TRANSMISSION RETARDER LOGIC CHANGE Prevost vehicles

On the vehicles affected by this bulletin, a 7psi pressure switch must be added to the transmission retarder circuit to activate the retarder when vehicle brakes are applied, increasing drivetrain components reliability.

Fig.3 Removing the module

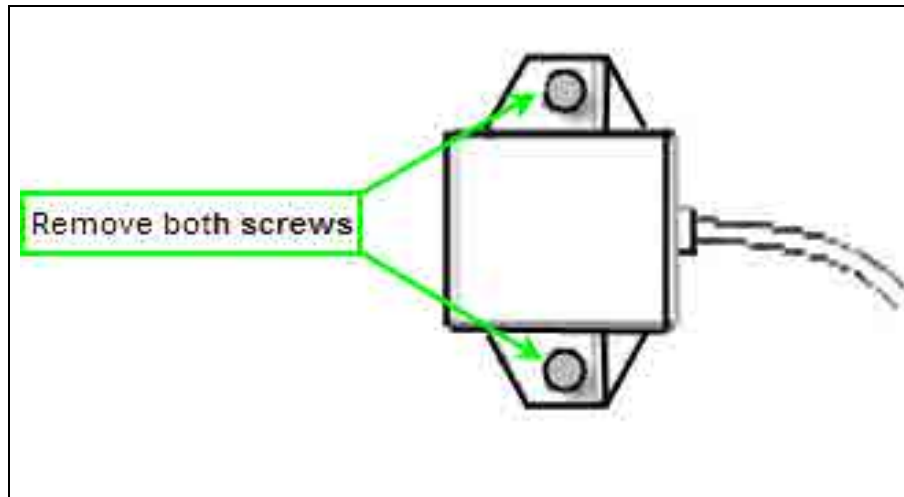
2. Disconnect the two pressure switches from the module.
3. Using a 5/16" hex socket, unscrew the two (2) module retaining hex screws and remove the module from the vehicle (Fig.3).

Fig.4 Third port on the junction block

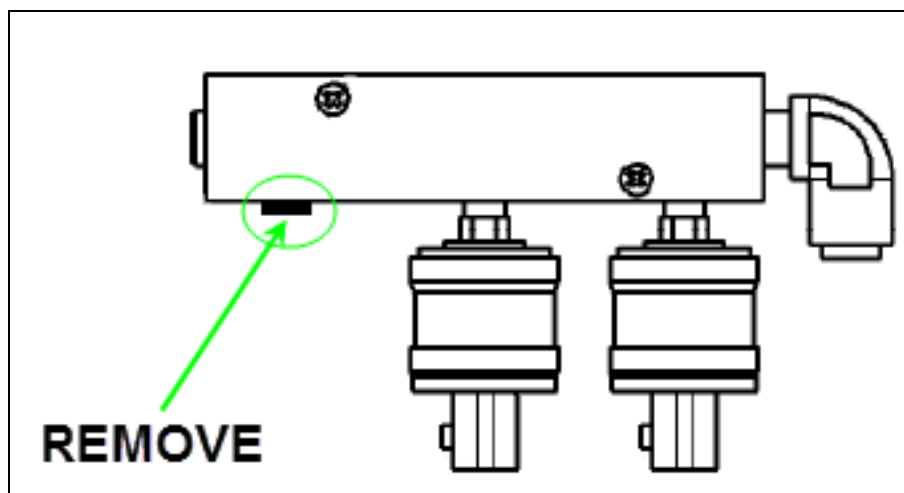
4. Using a 3/16" Allen hex key, Remove the plug that caps the third port of the pressure switches junction block (Fig.4).

Fig.5 7 PSI pressure switch installed at junction block

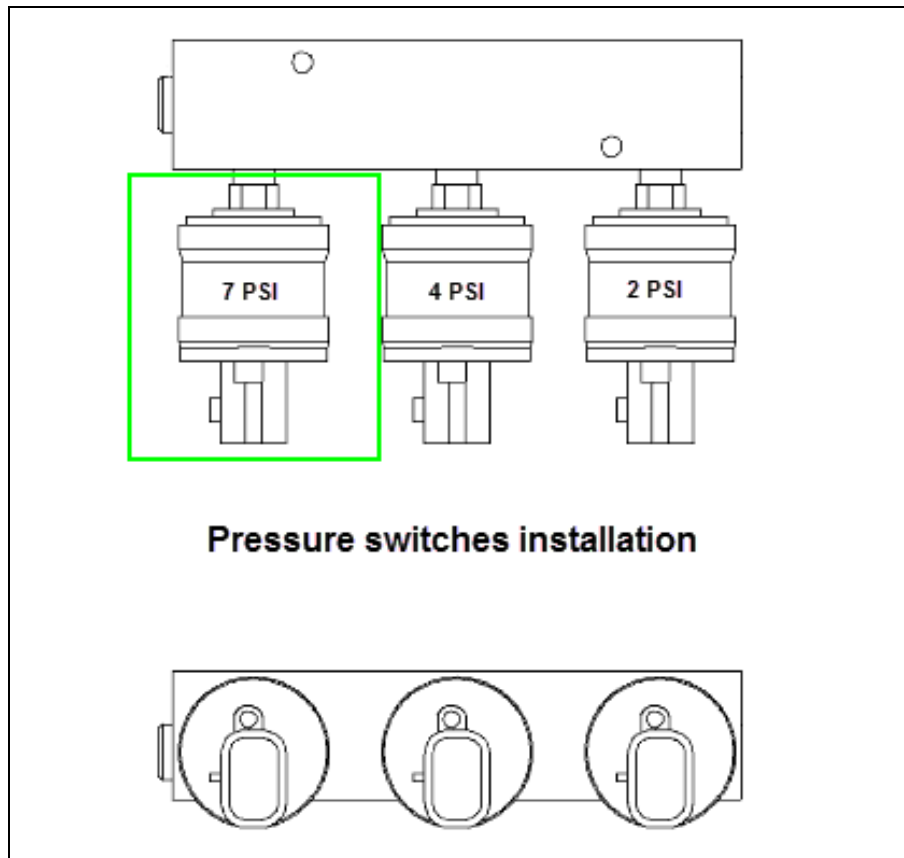
5. Install a new 7 psi pressure valve (part# 562385) in the third port on the junction block using Loctite 567 thread sealant (#680098) or equivalent on the pressure switch threads. The pressure switch must be first hand tightened in the junction block then tightened another 1 to 1 ½ final turn using a 1/2" wrench (Fig.5).

NOTE: Make sure the pressure switch connector lines up with the other two pressure switches.

Fig.6 Color identification of the connectors

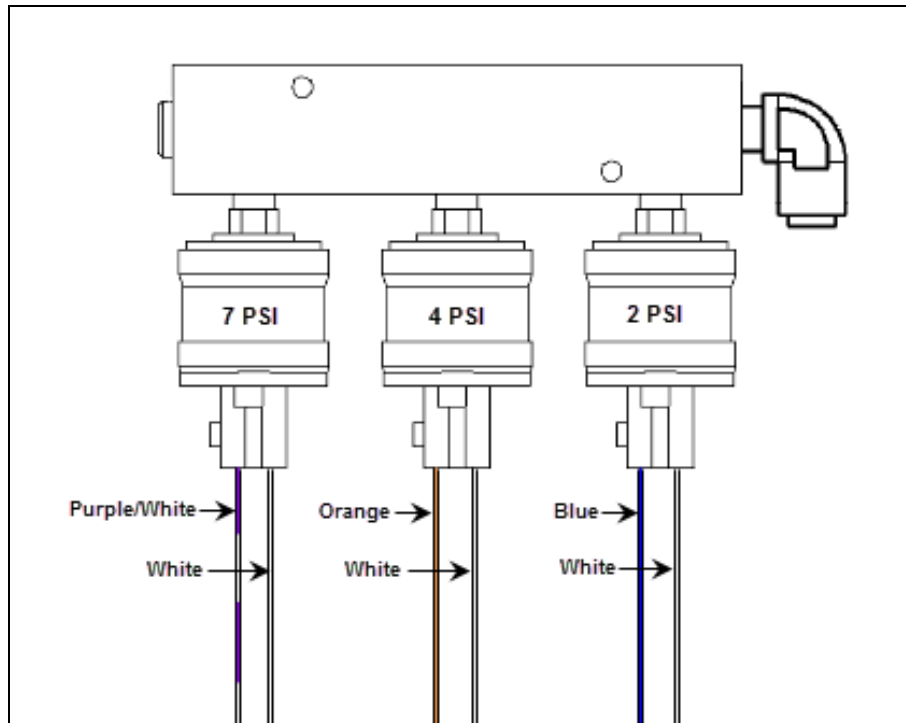
7. Connect the three (3) pressure switches to the new module (Fig.6 and Fig.7).

The three pressure switches connectors are identical. Be sure to connect them to their respective pressure switch to ensure correct retarder function. Refer to the connector wire color code shown in Fig.6 for proper connection of the module to the switches
